# St. Cronan's Avenue & Brackenstown Road Protected Cycle Lanes

## Public Engagement Report

Fingal County Council

May 2022

### Intersection of Brackenstown road and St Cronans Ave.

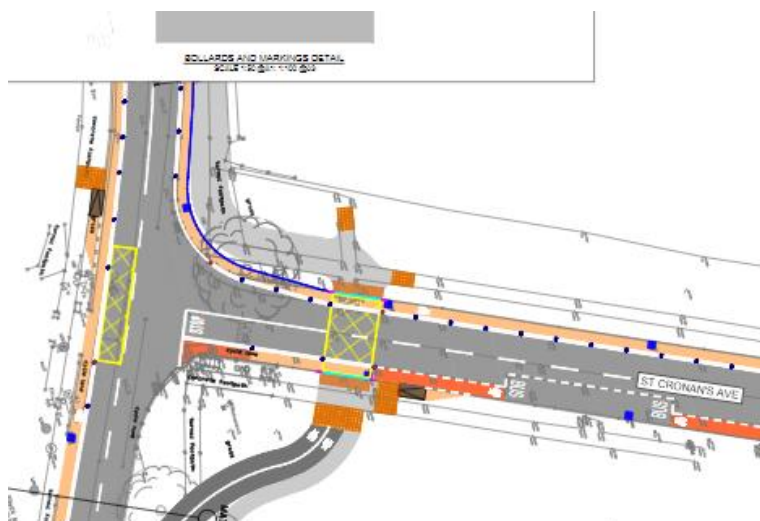
*Was consideration given to a Dutch type Roundabout at junction of St Cronan's Ave and Brackenstown Ave? This would facilitate safe walk and cycle routes and also reduce the delay for cars turning right from Cronans Ave onto Brackenstown Ave. It would also calm car speeds on the Brackenstown Ave at this location. On the Webinar the designers mentioned that this was not in scope for current works but could be a consideration for future phase in this area.*

*For cyclists heading south on Cronan's Ave could an access be made into the Ward Valley regional park.*

*For cars heading south on Cronans Ave to this intersection could consideration be given to a right and left turning lane for cars and routing the bike lane off the road. This can be a bottleneck at rush hour for cars and a dangerous intersection for bikes. A new pedestrian/bike raised crossing across Brackenstown Ave could be installed at this location (East of the junction).*

The reconfiguration of the St Cronan's Avenue junction with Brackenstown Road was originally outside the scope of the project. A design review will be conducted as part of the detailed design process in the current design and build contract.

### Brackenstown Road

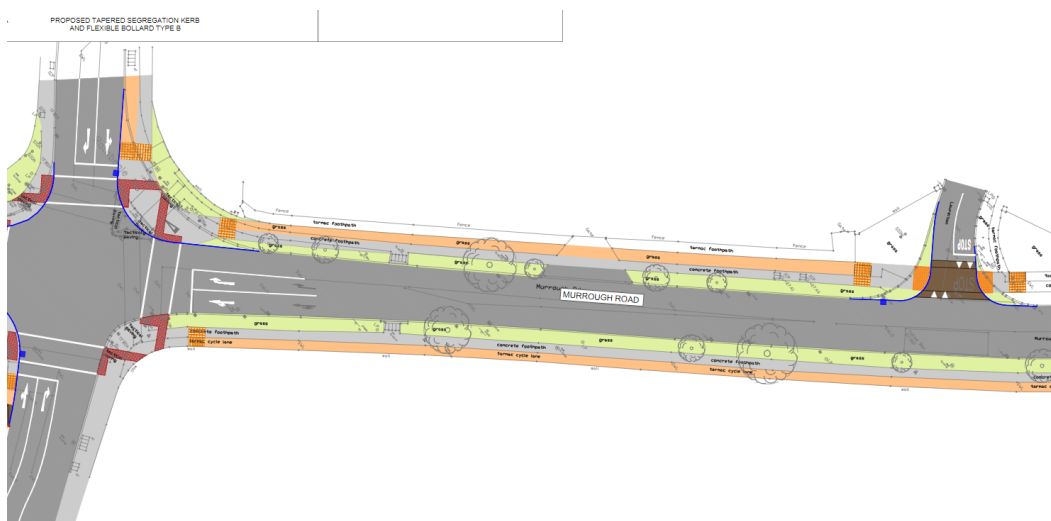
*A 2-way bike lane on this stretch up to Parkview could also have worked well given space available and would provide a safer option. Co-ordinate this with better crossing at exit points from Swords Manor.*

*Risk that bollards in the current plan will not stop from parking at entrance to Soccer pitches in Swords Manor. This could be one area where kerbs may be necessary. Most of the other areas in the plan that are provided with bollards are not subject to parking in the bike lane so bollards should be sufficient.*

While it may be possible to provide the cycle track between the trees at this location, other pinch points along the route mean it cannot be replicated for the full extent of the project. Weaving on road and off road may induce complacency by either cyclists or drivers and it is preferable to have consistency along the project. The NTA active travel proposals emphasise the reallocation of existing road space for the following reasons:

The issue with parking across the protected cycle tracks will be monitored following construction of the project and alternative measures implemented if considered necessary.

*Intersection of Brackenstown road and St Cronans Ave.*

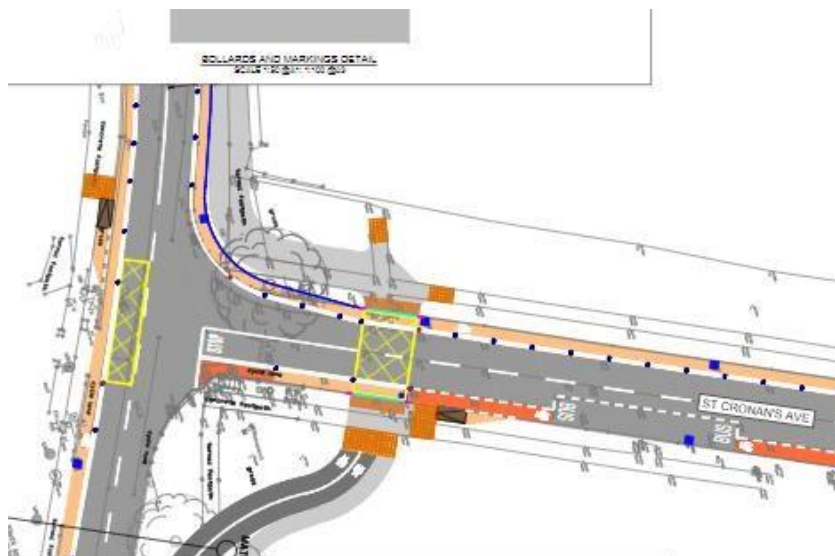
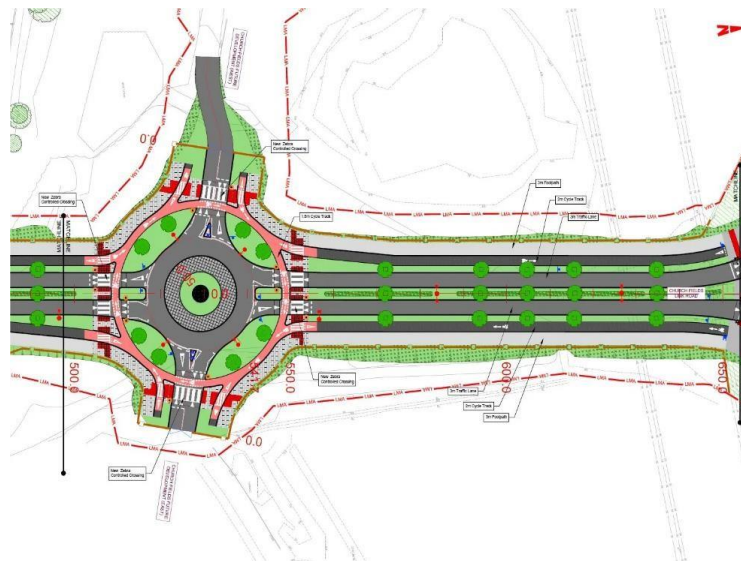
*A Dutch style Roundabout (diagram of one proposed for Dublin 15 below) at junction of St Cronan's Ave and Brackenstown Ave should be strongly considered. This would facilitate safe walk and cycle routes whilst reducing the delay for cars turning right from Cronans Ave onto Brackenstown Ave. It would also calm car speeds on the Brackenstown Ave at this location. In the Webinar, the designers mentioned that this was not in scope for current works but could be a consideration for future phase in this area.*

*For cyclists heading south on Cronan's Ave could an access be made into the Ward Valley regional park.*

*For cars heading south on Cronans Ave to this intersection could consideration be given to a right and left turning lane for cars and routing the bike lane off the road. This can be a bottleneck at rush hour for cars and a dangerous intersection for bikes. A new pedestrian/bike raised crossing across Brackenstown Ave could be installed at this location.*

See responses to FIN-C465-24.

*Section between Rathbeale road and Laureilton*

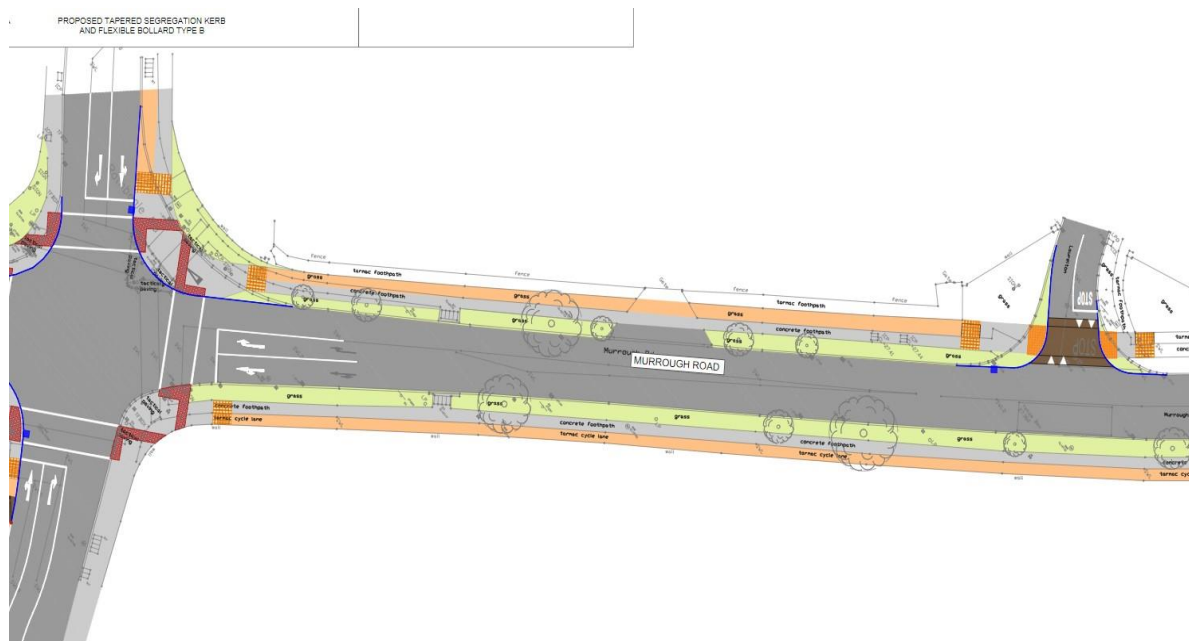
*No Cycle lane marked on this section*

The orange / peach colour on the section between Rathbeale Road and Laureilton is the proposed cycle track. It will be constructed through the existing grass verge to avoid impacting the existing trees. The "grass" reference is the topographical survey indicating its existing form.
